Re: Huntington Beach Energy Project (12-AFC-02)
Applicant's Correspondence Related to Air Quality

APPLICATION FOR CERTIFICATION FOR THE HUNTINGTON BEACH ENERGY PROJECT

Subject: RE: Written Comments on AES Huntington Beach Modeling Protocol Addendums

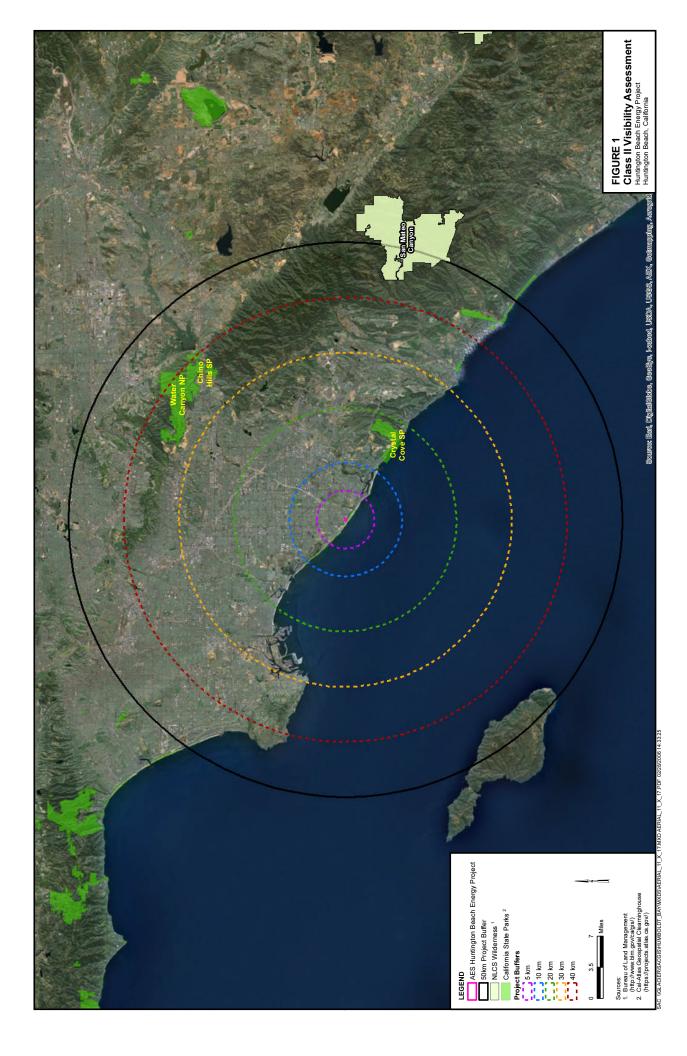
As we discussed earlier today, attached are the figures showing the Class II areas for a visibility assessment using the EPA recommended VISCREEN screening model. The parks and wilderness areas shown in these figures are the same as we discussed during our phone conversation earlier this week. The general procedures to determine visibility impacts would follow the approach outlined in *The Workbook for Plume Visual Impact Screening and Analysis (Revised)* (EPA-454/R-92-023. October 1992), with clarification of particular inputs below.

The background visual range for the Class II areas will be determined using the maps supplied on the IMPROVE website (http://www2.nature.nps.gov/air/monitoring/vismonresults.cfm). The middle of the range will be used. Example, for Crystal Cove State Park is between 95km and 110km background visual range. Therefore, 102.5-km will be used.

If a Tier I approach exceeds the Class I criteria for Delta E and Contrast, a Tier II assessment would be conducted. The Tier II assessment would utilize the AQMD pre-processed meteorological data for use in ISC. The ISC ready data is available for download on the AQMD website. The ISC data contain the wind speed, wind direction, and stability class for each hour of the year. These data are required to create the Joint Frequency distribution tables to calculate the Tier II wind speed and stability class for each area analyzed.

We have reviewed your proposed approach and we find that the choice of Class II areas to be analyzed is reasonable and agree with the use of the Class I criteria to determine the significance of the visibility impacts. However, we do not agree with the use of ISC meteorological data to populate the joint frequency tables. The meteorological data used for AERMOD should be used, so that consistency is maintained with the meteorological data used for the other dispersion modeling aspects of this project.
